**FINDINGS AND RECOMMENDATION
OFFICE OF PLANNING AND ZONING
ANNE ARUNDEL COUNTY, MARYLAND**

CASE NUMBER: 2023-0072-V

REQUEST

The applicants are requesting variances to allow a dwelling addition (deck) and accessory structure (pool) with disturbance to slopes of 15% or greater on property located at 2939 Broad Court in Annapolis.

ADMINISTRATIVE SITE PLAN

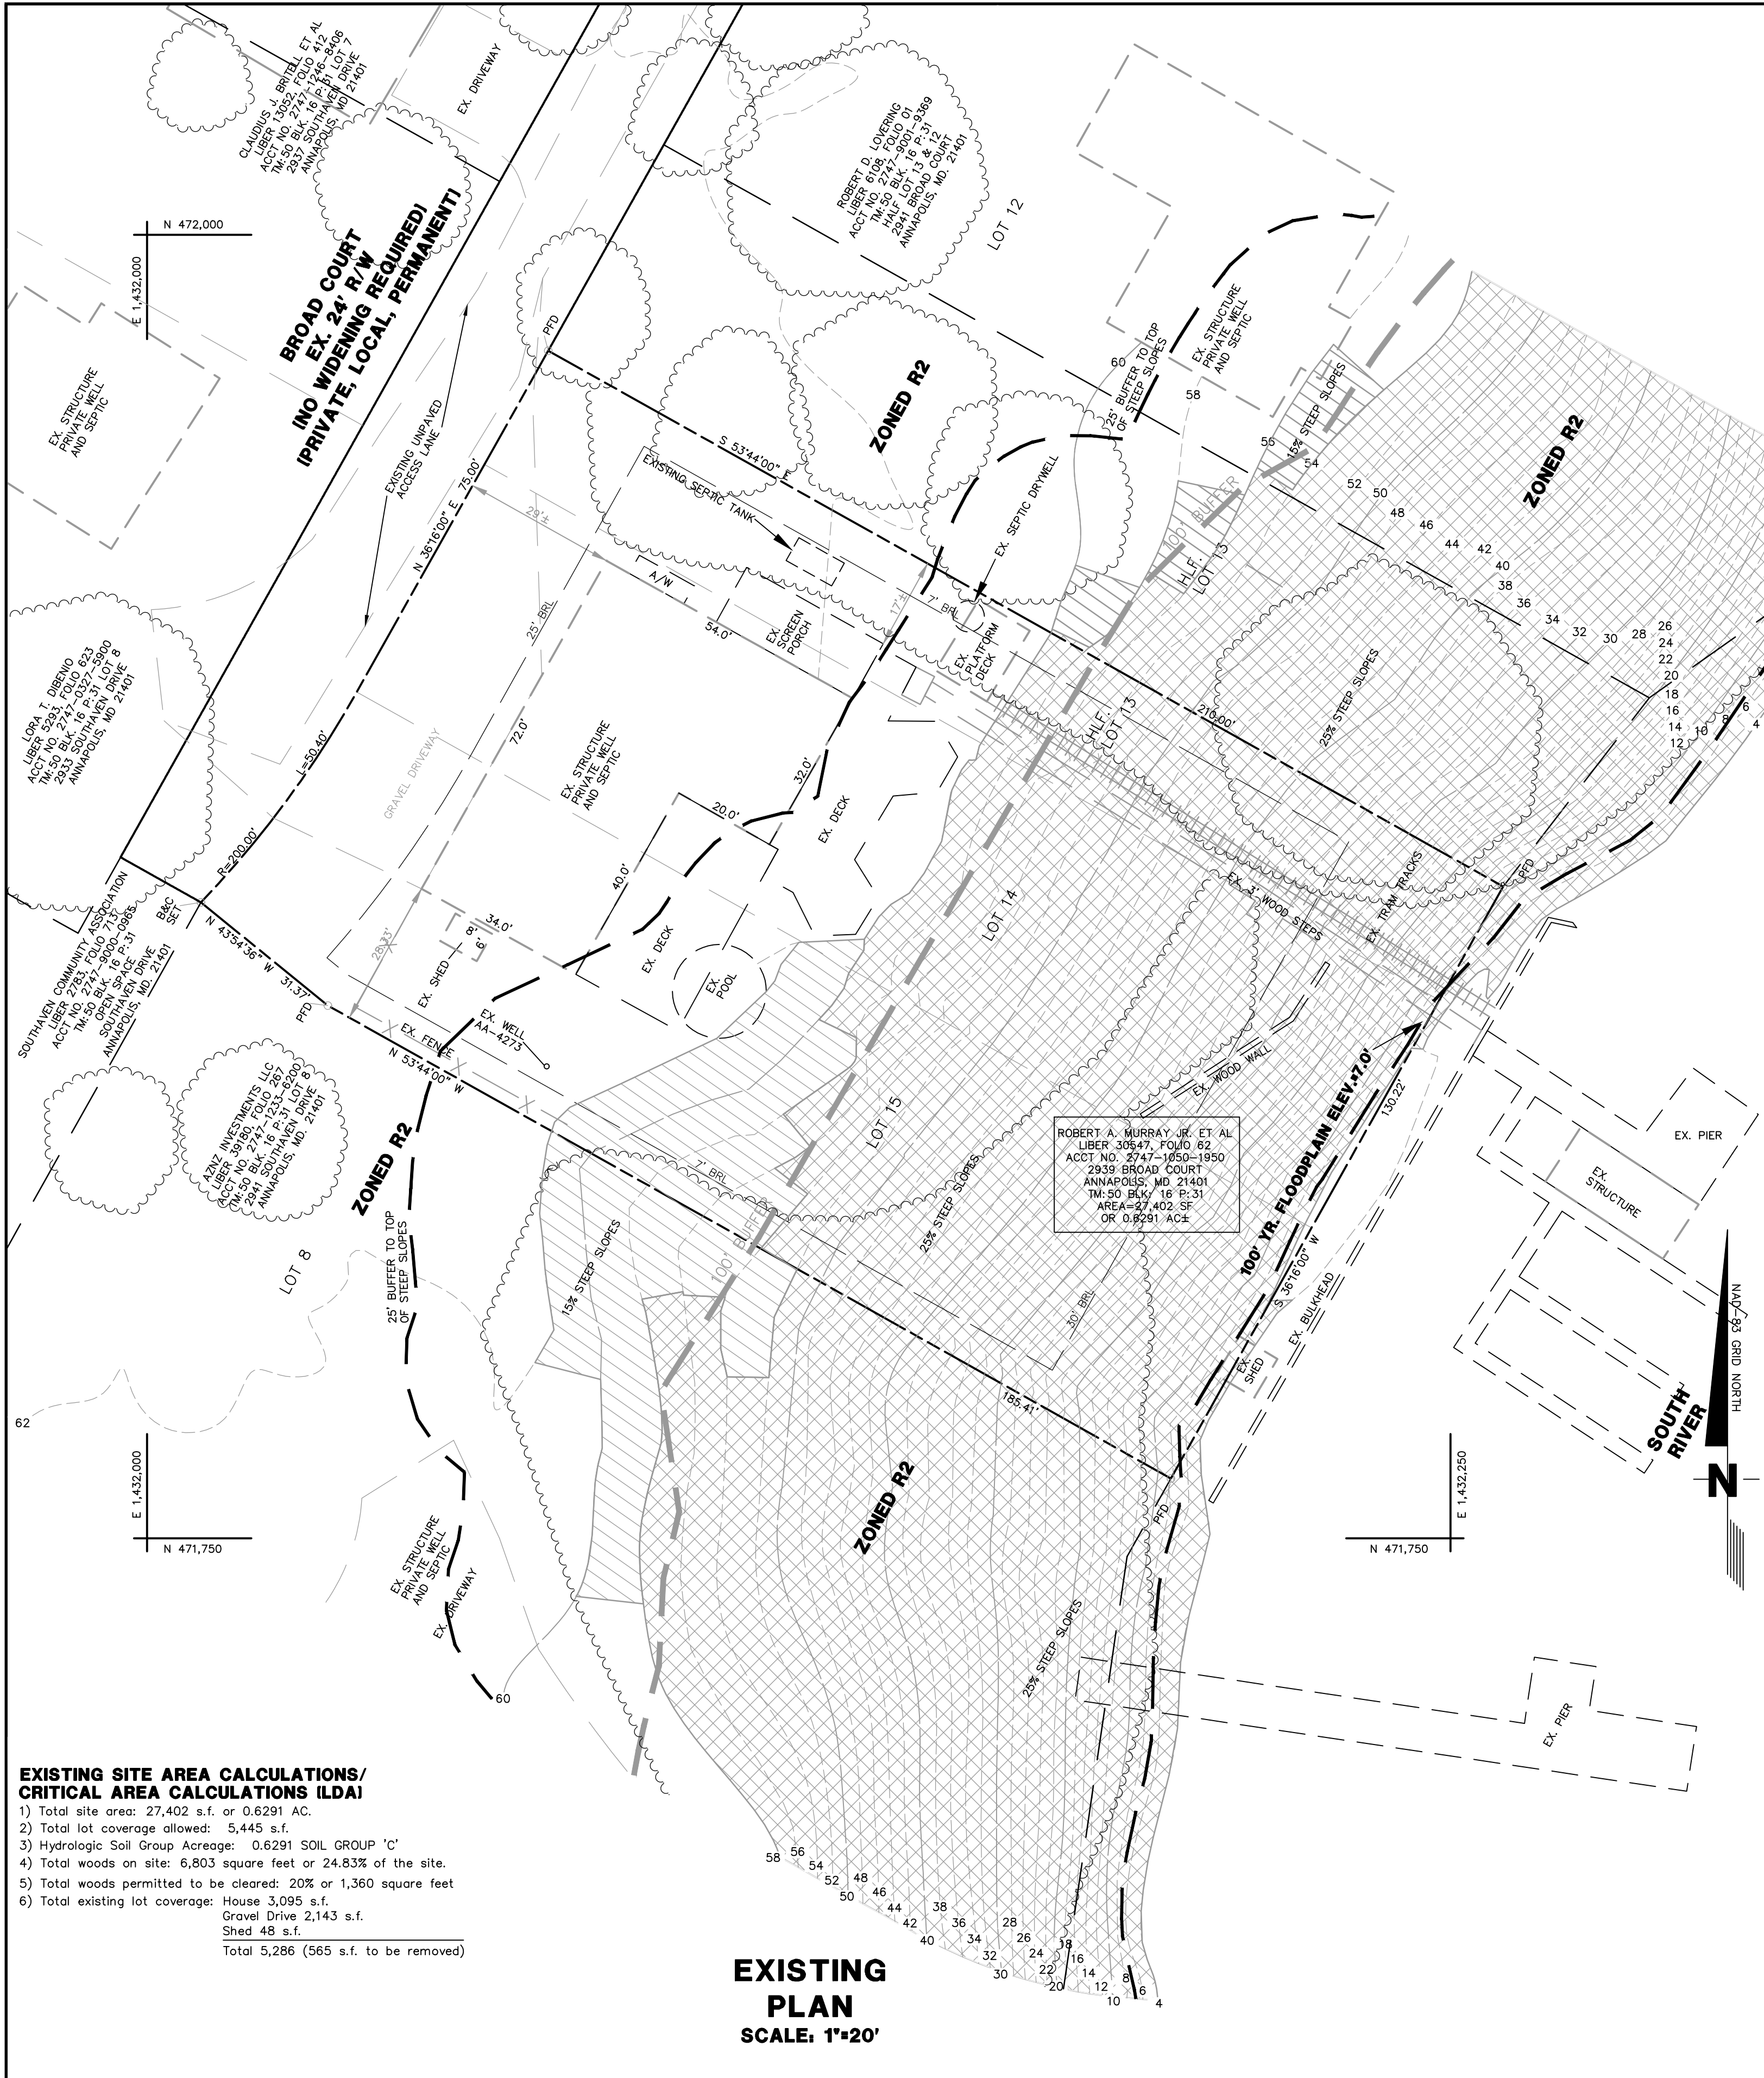
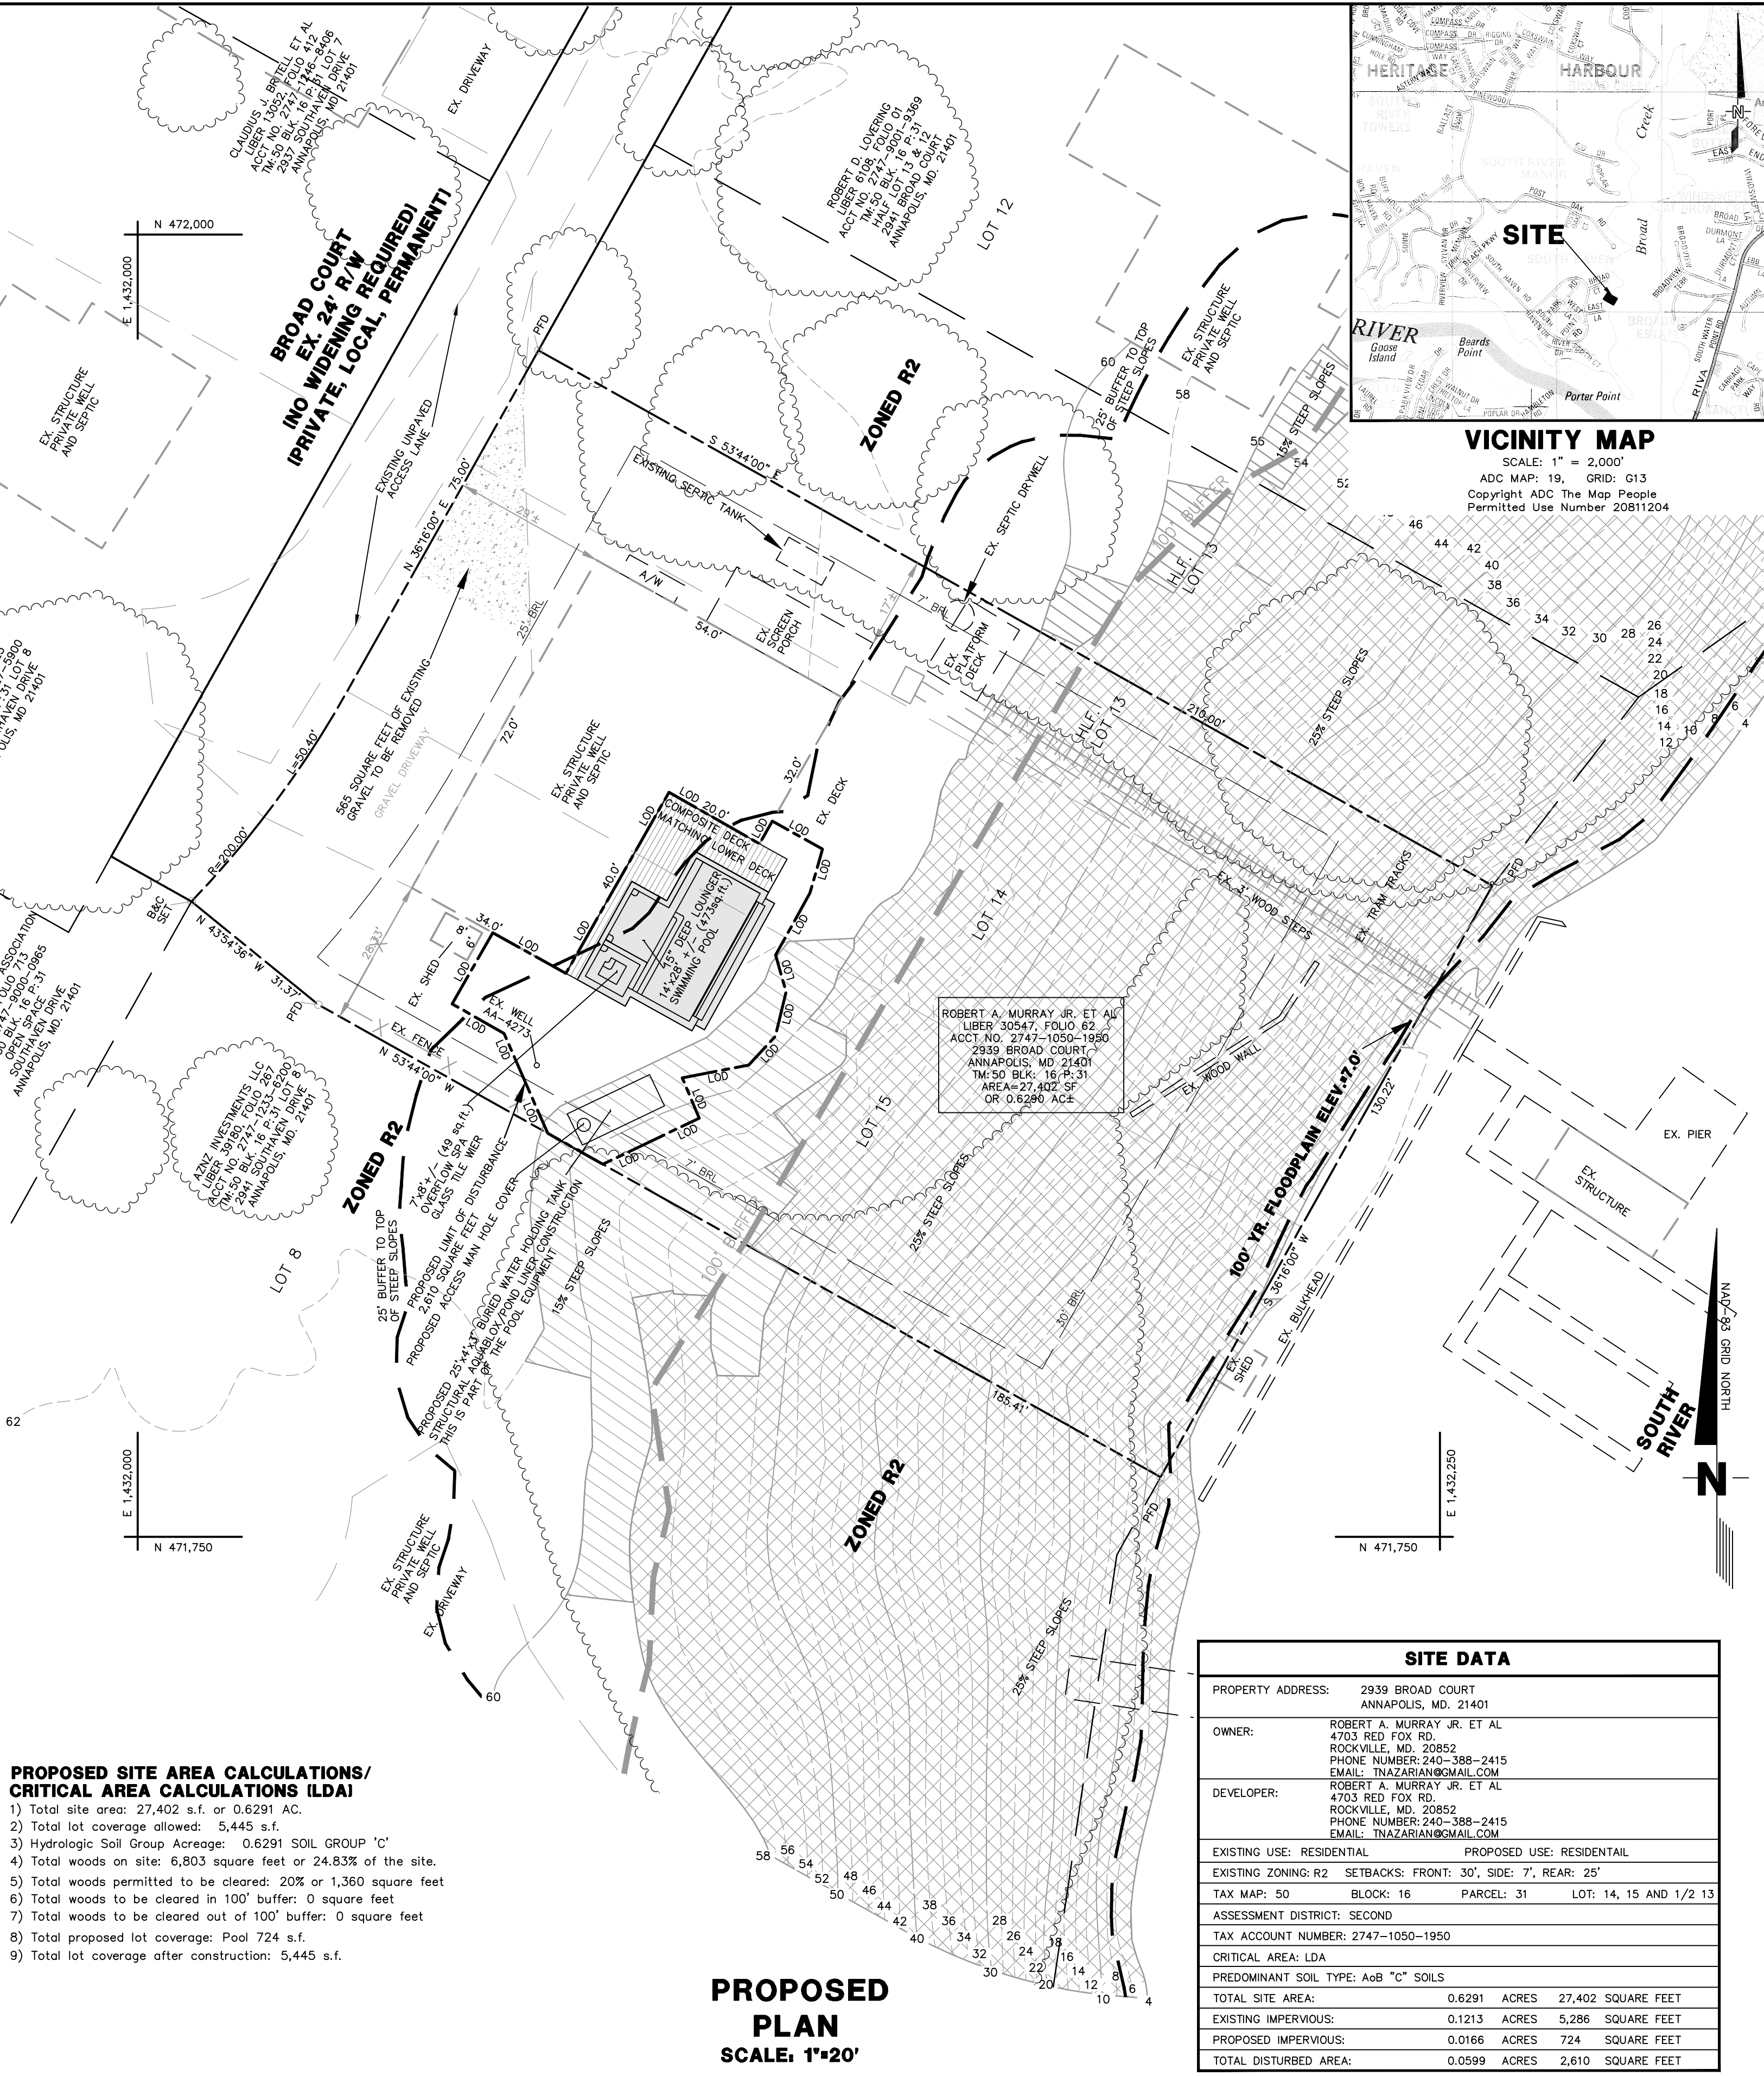
The **Development Division (Critical Area Team)** commented that the applicant is proposing to excavate at the top of a 53% slope leading directly to a tributary on the South River. Profile comments indicated that this office could not support this type of activity and although there was a slight adjustment to the plans, the applicant is still seeking to impact the required buffer. This

The applicants are proposing to replace the existing deck with a smaller reconfigured deck, and to replace the existing above-ground pool with a larger in-ground pool. The proposed pool includes a spa, a sun lounge, and a vanishing edge catch basin. The revised plans have reduced the size of the proposed deck and pool, which is further from the existing well and marginally further from the top of the steep slopes. However, the proposed buried water housing tank, not drawn to the indicated 25'x4'x3', is still shown within the steep slopes. Because the dimensions are not accurate to the drawing, the disturbance area cannot be verified.

Whereas the existing pool is located within steep slopes, and the proposed pool would be excavated at the edge of steep slopes, the existing deck and the proposed deck are located entirely outside of steep slopes. Since the proposed deck configuration is reliant on the proposed

pool configuration, its variance request will not be supported. However, the removal and replacement of the existing deck with a similar structure would only temporarily disturb a small portion of the steep slopes, and would be supported.

However, the request is not considered to be the minimum necessary to afford relief as there is opportunity to reduce the proposed pool size and shift its location in order to minimize disturbance.

Based upon the standards set forth in § 18-16-305 of the County Code under which a variance may be granted, as proposed, this Office recommends *denial* of the Critical Area variance request to § 17-8-201(a) to disturb steep slopes. However, the County would support the approval of a variance to allow disturbance of steep slopes for the replacement in-kind² of the existing deck and pool.
